SERVICE No. 522 BULLETIN

"Modification DOA EA-1 Approved"

September 28, 1976 S

Subject: Wing Fuel Tank Cap Modification.

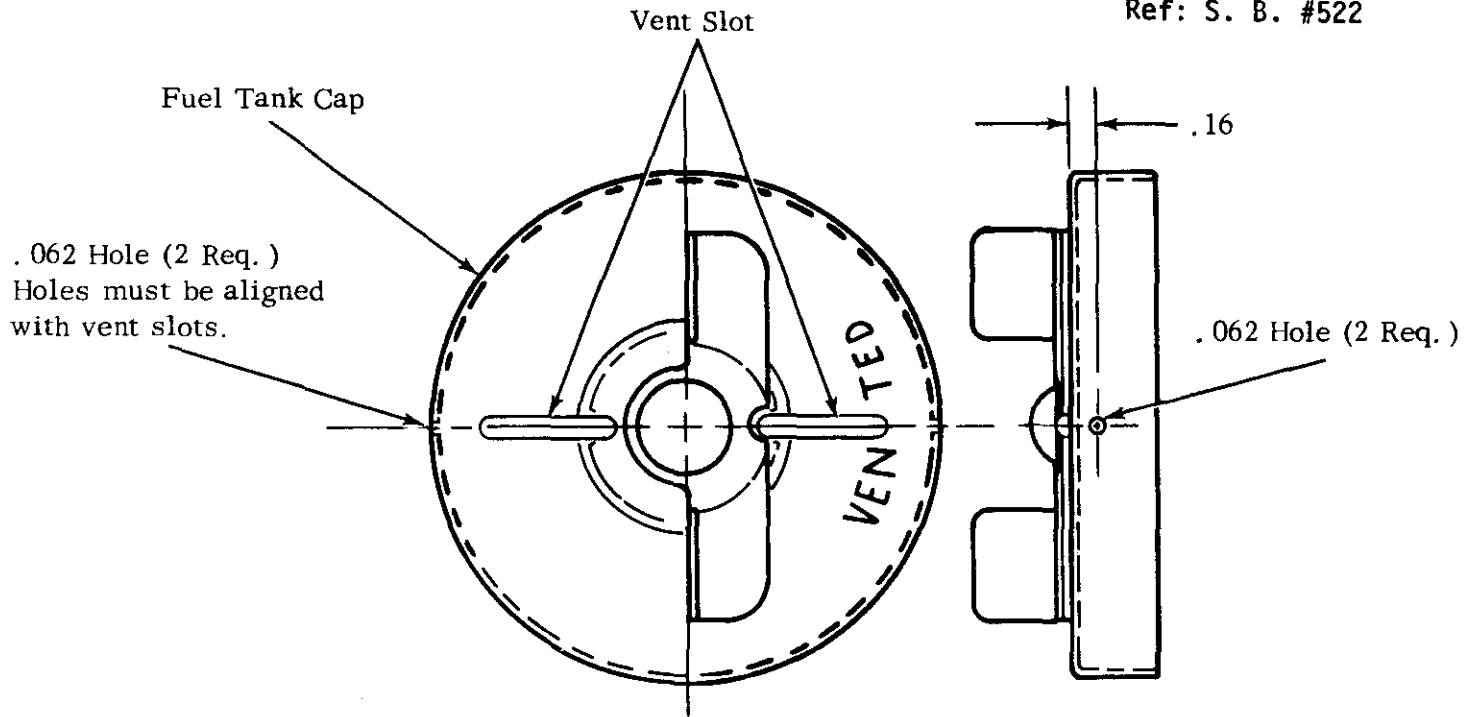
This service release provides instructions to apply additional vent holes in the fuel tank cap to allow continued positive fuel tank venting in the event that the tank filler neck gasket inadvertently develops a seal between the filler neck and the fuel tank cap. The attached sketch illustrates the above referenced fuel tank cap modification and proper installation of the fuel tank filler neck gasket.

1. Remove fuel tank caps from wings and rework caps by drilling two .062 holes .16 down from top of cap. Holes must be aligned with vent slots as shown.
2. Inspect rubber seal around fuel tank inlet to determine if seal is properly installed as shown.
 - a. If seal is not installed correctly, remove fuel tank cover from wing, reposition seal as shown and reinstall fuel tank cover.
3. Reinstall reworked fuel tank caps and make proper logbook entry of Service Bulletin 522 compliance.
